# VAN'S AIRCRAFT

### SERVICE BULLETIN 18-03-30

**Subject:** Elevator stop inspection

**Affected Models:** RV-10 aircraft with empennage kits purchased after April 2012

**FIGURE 1: NORMAL CONTROL STOP OPERATION**

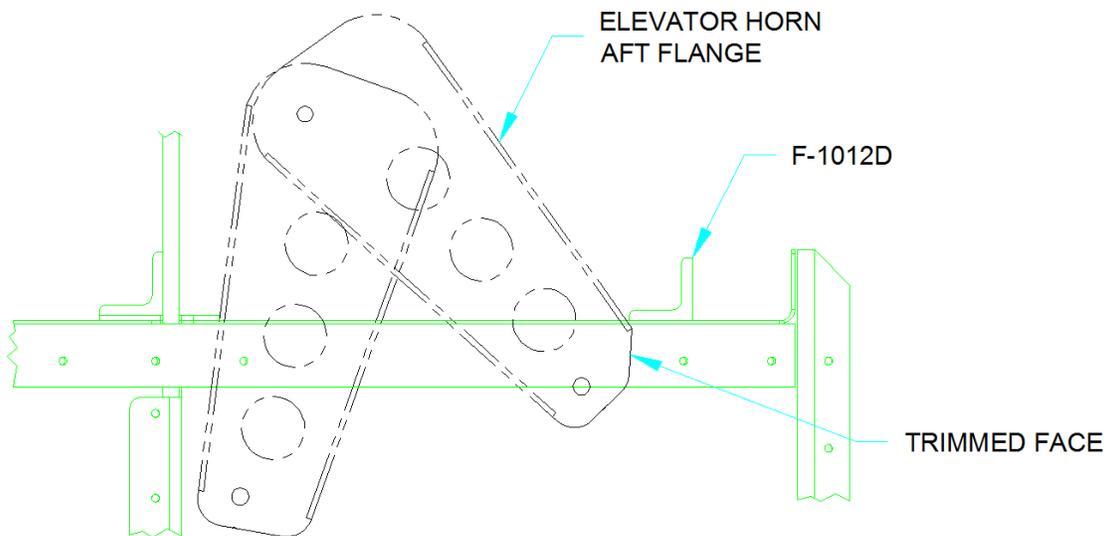
In April 2012 the lower aft portion of the elevator horn was removed. See the trimmed face called out in Figure 1. This portion of the horn typically needs to be removed for use on most RV aircraft. The RV-10 does not require this trim. It has come to our attention that due to production tolerances it would be possible for the horn to jam against the up elevator control stop. This condition would also permit excessive elevator up travel. If either of these problems exist, the aft stop F-1012D Up Elevator Stop should be replaced.

Step 2: Inspect the pitch control system for proper contact of elevator control horn aft flange against the F-1012D Up Elevator Stop as shown in Figure 1. An improper installation in which the flange does not make contact is shown in Figure 2. If your aircraft matches Figure 1 proceed to the last step of this service bulletin. If your aircraft matches Figure 2 proceed to the next step.

**FIGURE 3: MODIFIED UP ELEVATOR STOP TOP VIEW**

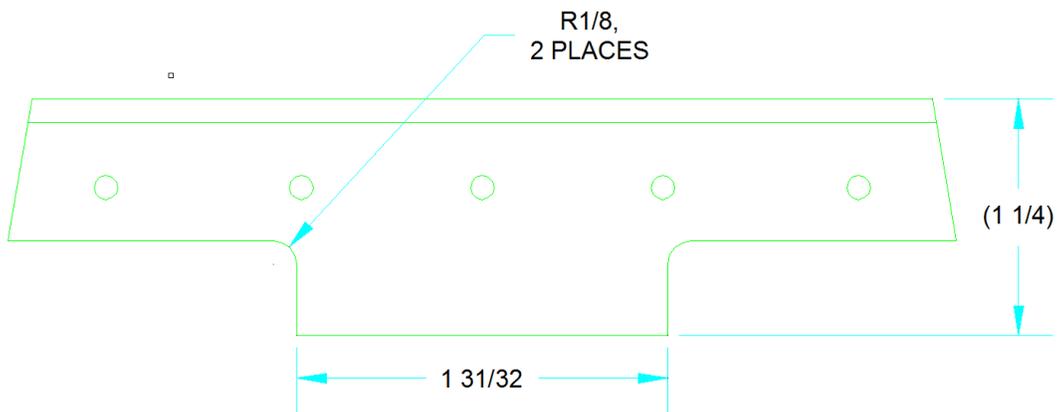
**Step 4:** Order the angle called out in the parts section of this Service Bulletin from Van's Aircraft. Remake the F-1012D Up Elevator Stop as shown on RV-10 Page 10-13 and Figure 3. Trim the vertical flange to match the original 3/4 inch height. Leave the horizontal flange longer as shown in Figure 3.

Clamp the up elevator stop angle in place on the fuselage and match-drill the old #30 and #12 holes from the fuselage into the angle.

**Step 5:** Install the new F-1012D Up Elevator Stop as shown on RV-10 Page 10-13, 10-21 and 10-22. Adjust the control stop as shown on RV-10 Page 11-06 to permit the correct amount of elevator travel. It is permissible to use a spacer underneath F-1012D if necessary.
